HISTORIC PRESERVATION COMMISSION

Case #: HPC 2017.093
Date: November 28, 2017

PRESERVATION STAFF REPORT

Petition: Somerville Hispanic Association for Community Development, Owner, seeks permission from the Somerville Historic Preservation Commission (HPC) to alter north side entry and walkway to meet ADA requirements.

1 MATERIALS AND PLANTING PLAN

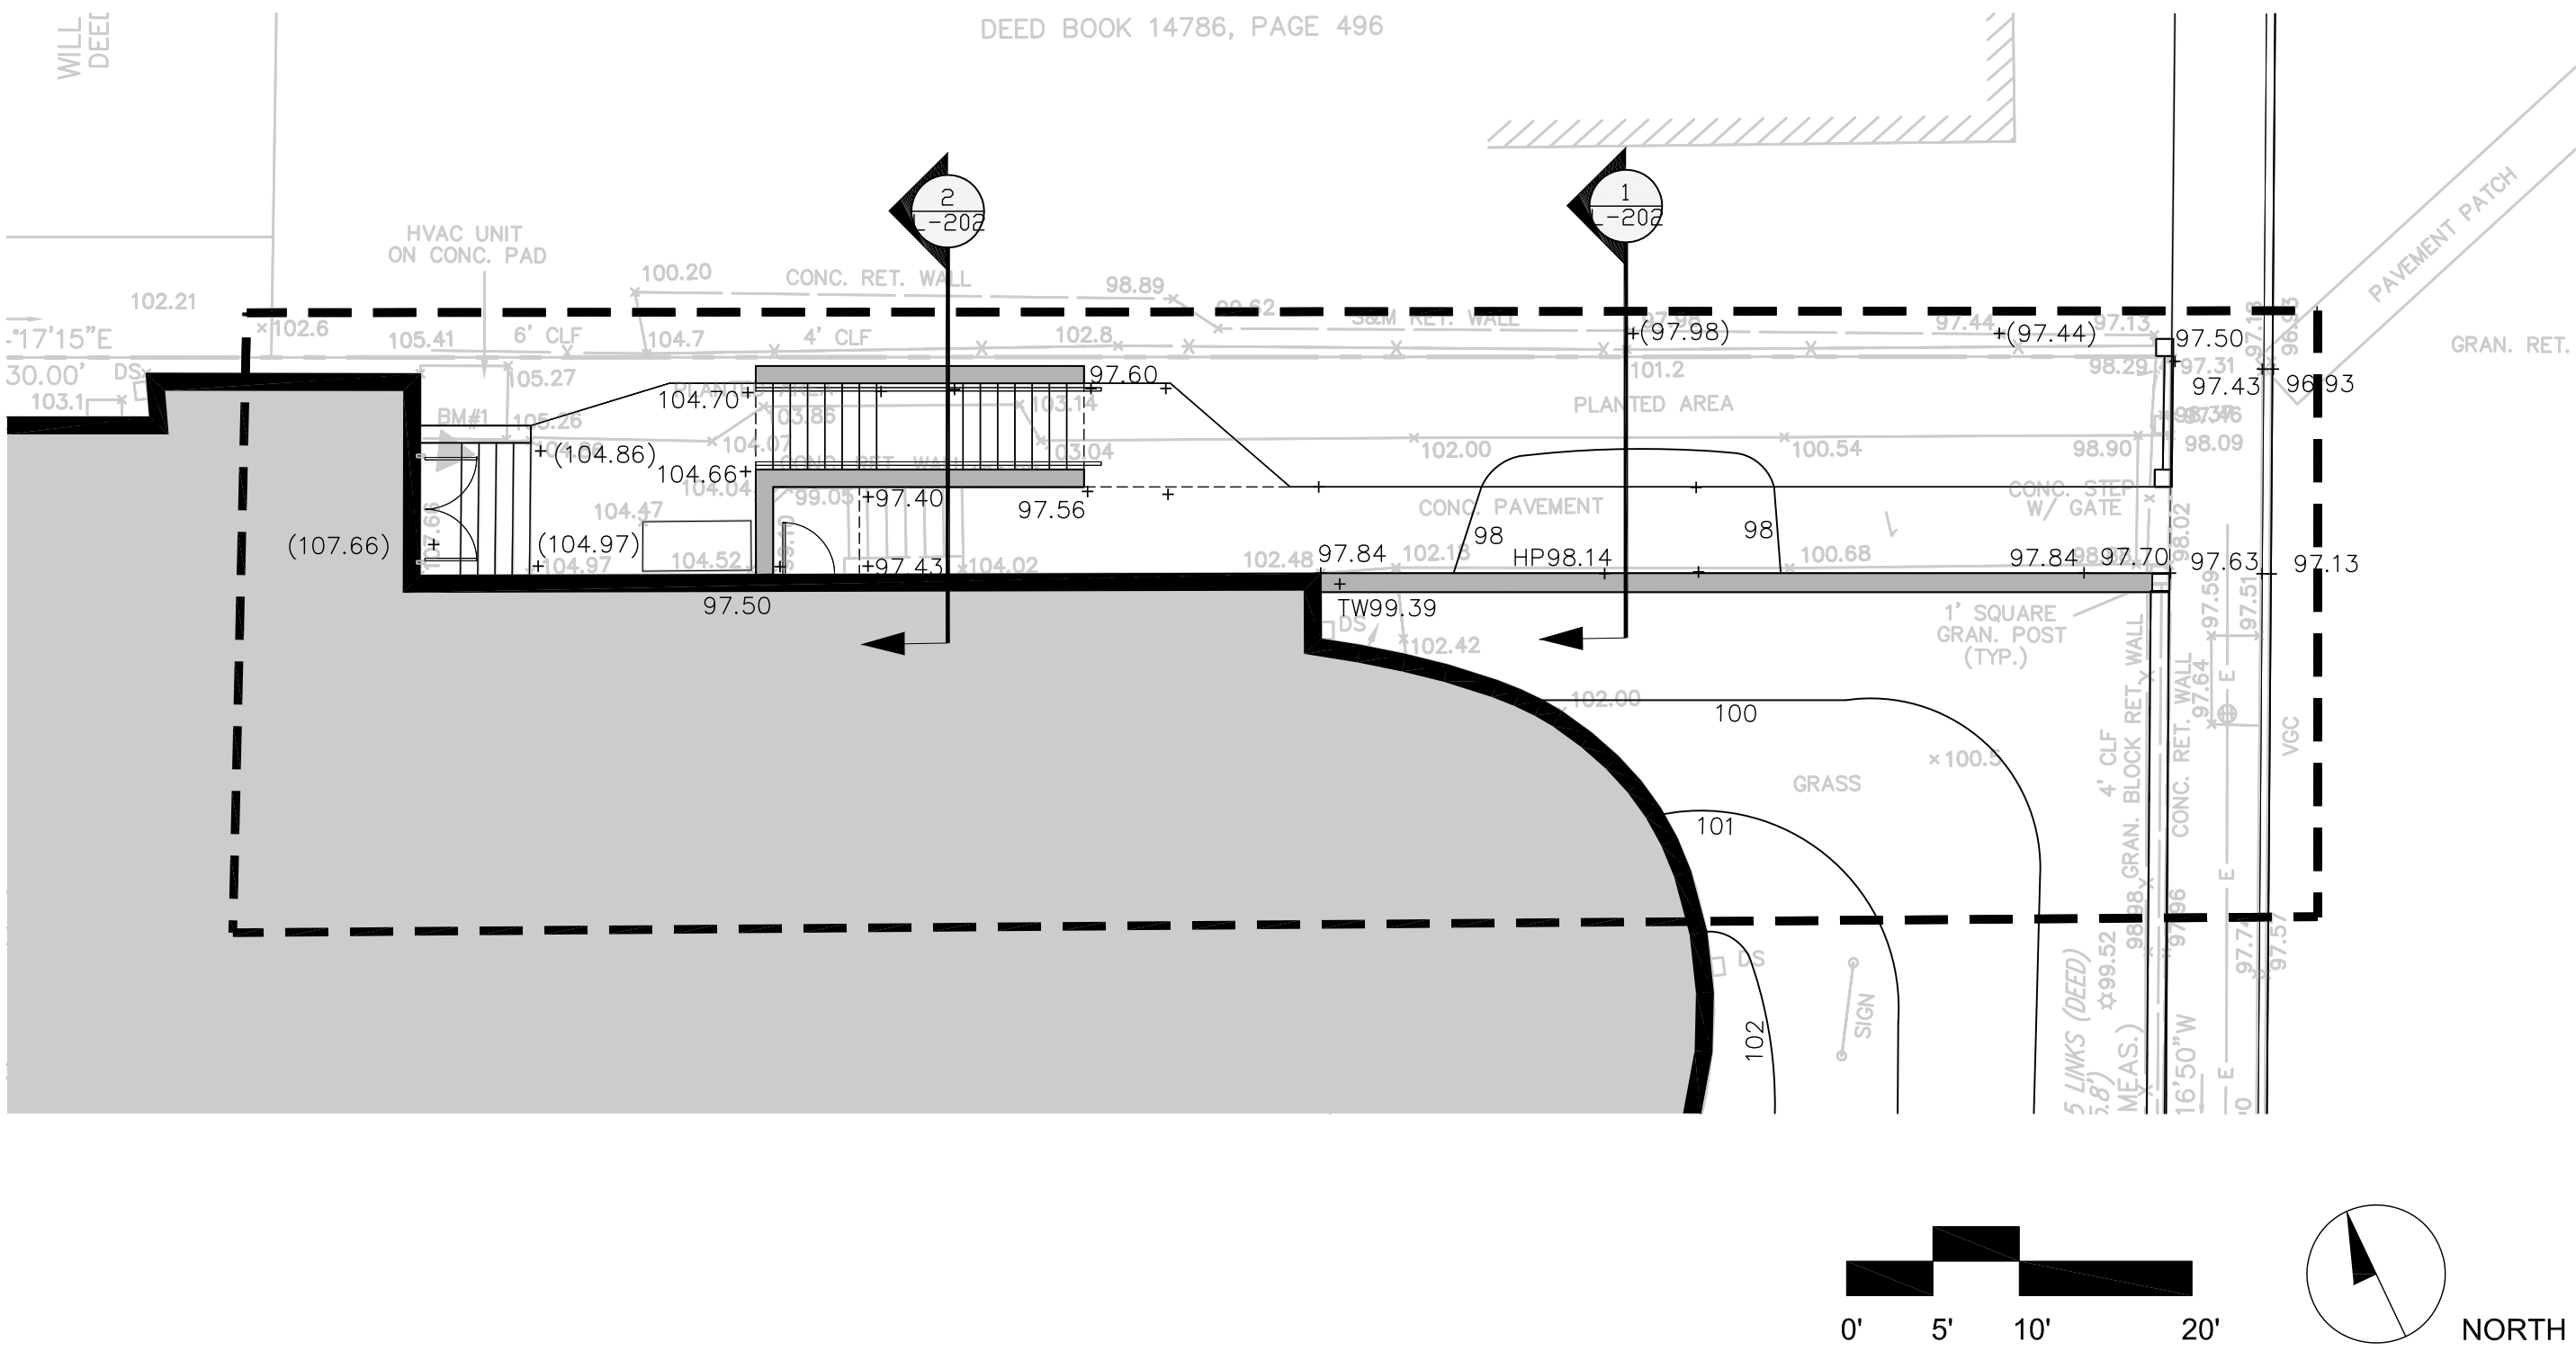
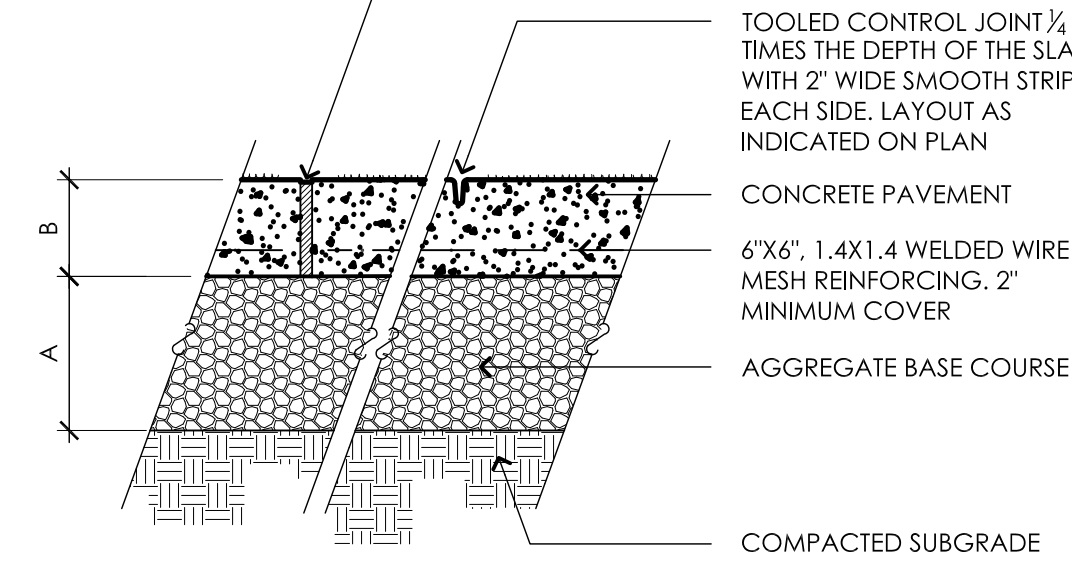
To meet the ADA requirements the steps up to the path from the sidewalk will be removed. The pathway will slope down to meet the side entry of the apse basement. The pathway will fork and skirt around the apse entry area to meet the existing north entry to the nave. Steps will be added to the pathway at the fork to bring the entries into alignment.

Staff Findings: Staff finds that the planned walkway meets guidelines for ADA accessibility and does not significantly detract from the historic character of the church building.

Based on the information provided and an assessment of the proposal against the Somerville LHD guidelines, Staff recommends A Certificate of Appropriateness for the new ADA ramps and entry with the following conditions:

1. All appropriate building permits shall be obtained prior to the start of any work.
2. If changes are necessary to the proposed design for which this Certificate of Appropriateness was issued, new plans shall be submitted to Historic Staff prior to commencing the work.
3. The ramps, steps and entry shall be constructed as found on the plans by Spencer and Vogt Group D100, D101, A100, A101 and A500 dated 2017.11.8 for Project Number 1705.00 and plans by DMLA for Spencer and Vogt Group L-101, L-201 and L202 dated 2017.11.1 for Project Number 1711.
4. Historic Staff shall issue a sign-off upon completion of the project that this was done in accordance with the Certificate and approved plans.
